GOVERNMENT OF THE DISTRICT OF COLUMBIA
DEPARTMENT OF TRANSPORTATION

MEMORANDUM

SUBJECT: BZA Case No. 19103 – 5th and I Streets Hotel and Residential

Figure 1: Site Design and Access (Source: Grove/Slade Associates)

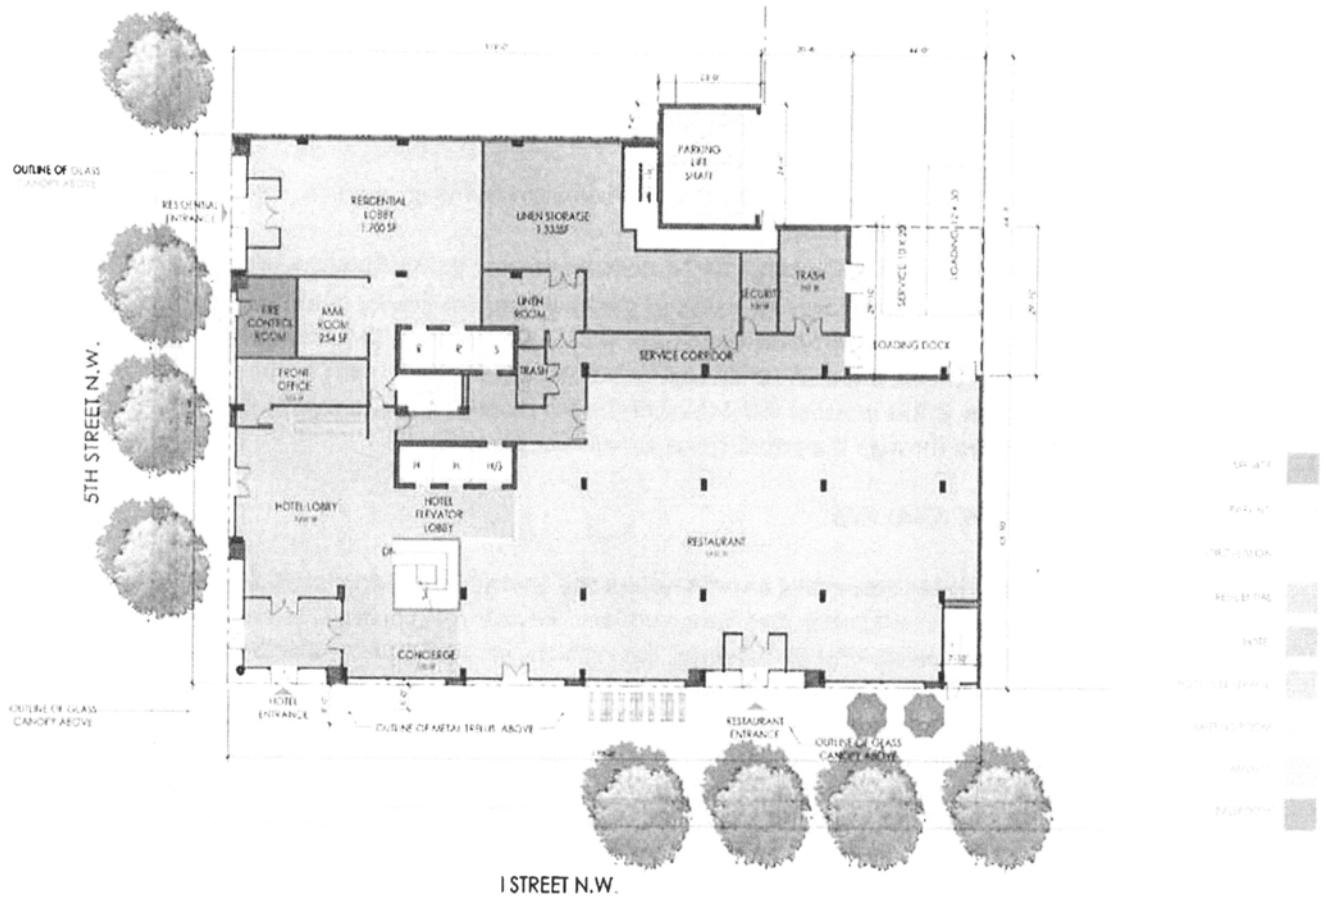
The Applicant proposes off-street parking and loading access to the site through an existing public alley that connects to K Street and I Street. No curb cuts are proposed for the site (see Figures 1 and 2). All vehicle parking access is proposed to be managed by valet operators, who will access the parking garage from the alley through two mechanical parking lifts.

DDOT expects the Applicant to design and build the streetscape surrounding the property to current DDOT standards, including building canopies, trellis, and planters as noted on site plans. The proposed site plans also show a layby on I Street, which DDOT is unlikely to support during the public space permitting process. Since the Applicant intends to reserve curbside parking spaces for a valet staging zone, a layby is not necessary, reduces the clear pedestrian path in the sidewalk, which is vital with valet staging, and reduces the number of street trees. In lieu of a layby, the curb and gutter should be maintained and street trees planted at the curb.

Figure 2: Valet Operations (Source: Grove/Slade Associates)

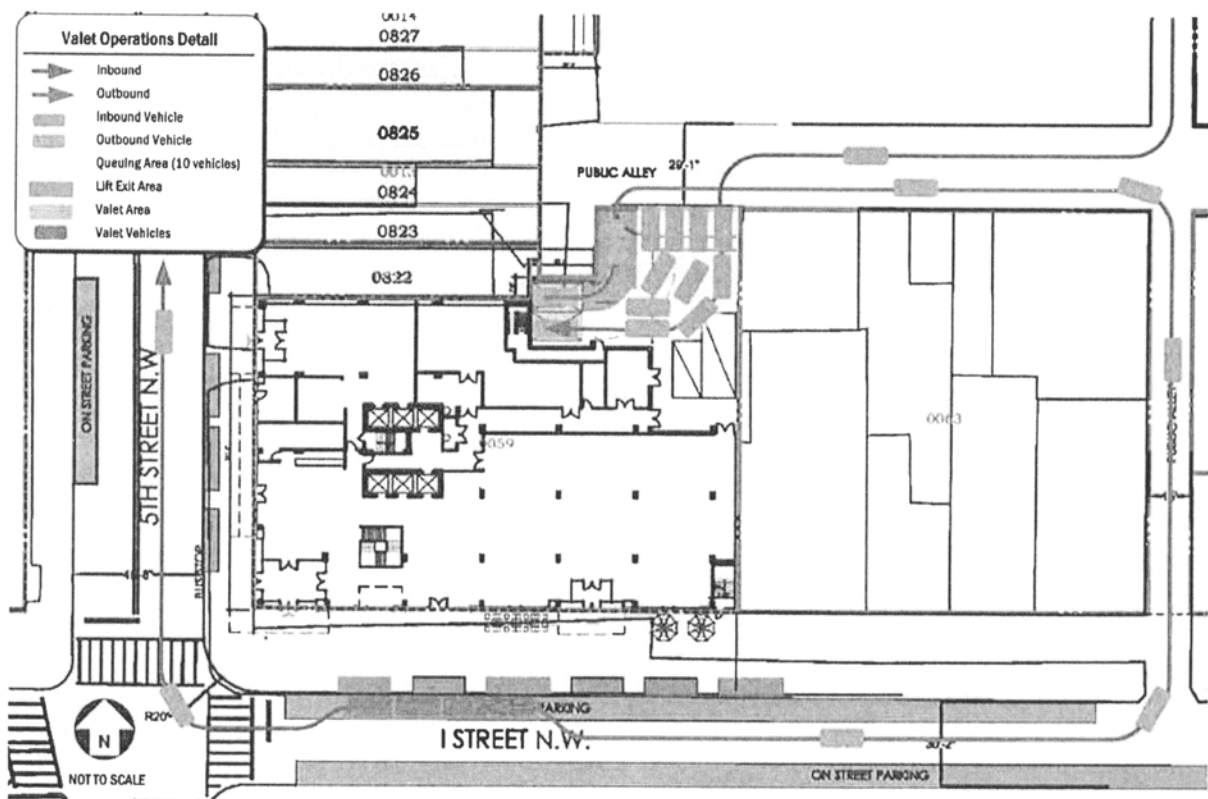
The Applicant proposes providing one 30-foot loading berth and one 20-foot service, one 100-foot loading platform in conformance with the zoning requirements. No back-in maneuvers will occur on public space. The location of vehicles queuing to enter the parking garage via the mechanical parking lifts is in front of the loading area, which results in blocking access to the loading space (see Figure 2). This queuing location will not prevent access for neighboring properties that utilize the alley. While DDOT finds the vehicle queuing location appropriate, a loading management plan is necessary to address conflicts between valet queuing and the loading area.

The location of vehicles queuing to enter the parking garage via the mechanical parking lifts is in front of the loading area, which results in blocking access to the loading space (see Figure 2). This queuing location will not prevent access for neighboring properties that utilize the alley. While DDOT finds the vehicle queuing location appropriate, a loading management plan is necessary to address conflicts between valet queuing and the loading area.

- Provide a loading management plan to address conflicts between valet queuing off of the alley and the loading area;
- The Applicant should commit to a minimum of seven valet operators during peak operations as noted in their report dated November 5, 2015 to minimize potential I Street conflicts;

Figure 8: Parking Level Layout and Parking Space Lift (Source: Grove/Slade Associates)

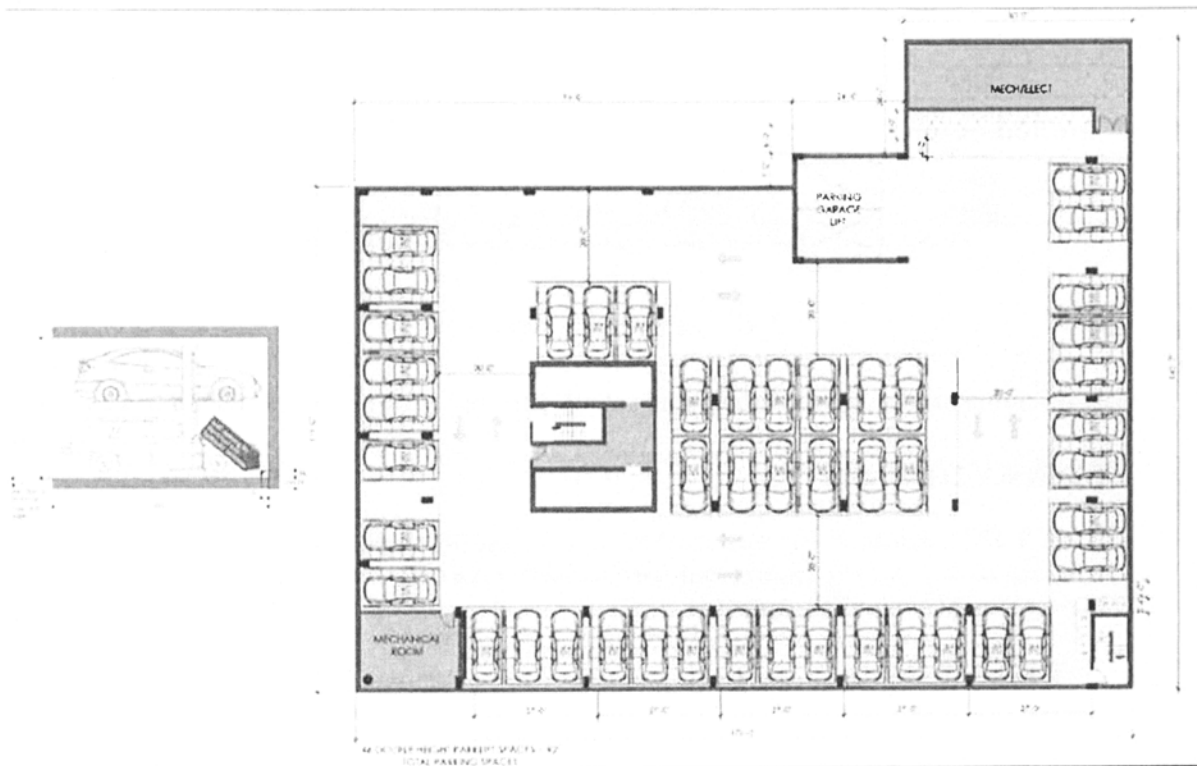
As previously noted, all vehicle parking access is proposed to be managed by valet operators, who will access the parking garage from the alley through two mechanical parking lifts. Valet staging is proposed to occur on I Street. To minimize impediments to traffic operations as vehicles queue to be dropped off or picked up, the Applicant proposed queuing up to 10 vehicles in front of the loading area in private space (see Figure 2). The parking garage can hold a minimum of 92 vehicles, which will be accommodated among 46 striped parking spaces through the use of individual space parking lifts holding two cars each (see Figure 8).

The two mechanical lifts accessing the garage can accommodate a total of 80 vehicles per hour (40 entering and 40 exiting) with each lift taking three minutes to complete a cycle of up and down. As previously noted, a conservative estimate of 51 vehicles could enter or exit the site during the PM peak hour. With the use of these two types of parking lifts (i.e., the lifts accessing the parking garage and the lifts within the parking garage) and travel time to and from the valet staging area, the Applicant predicts

that each valet will take 11 to 12 minutes to make one roundtrip valet operation (i.e., park one car and retrieve one car), or approximately five to six roundtrips per hour. At peak PM operation, this would require a staff seven or eight valets and a valet manager for continuous operation. The Applicant has also stated that the arrival of vehicles in significant numbers is not expected for any uses on site, including the ballroom. In the event that a significant number of vehicles depart within a short period, the Applicant has agreed to manage valet operations so as not to block the alley or through lanes along I Street. DDOT will not permit double stacking vehicles on I Street impeding traffic operations as vehicles queue for valets or valets queue for pickup. Therefore, the Applicant should commit to a minimum of seven valet operators during peak operations as noted in their report dated November 5, 2015.

- Provide a loading management plan to address conflicts between valet queuing off of the alley and the loading area;
- The Applicant should commit to a minimum of seven valet operators during peak operations as noted in their report dated November 5, 2015 to minimize potential I Street conflicts; and
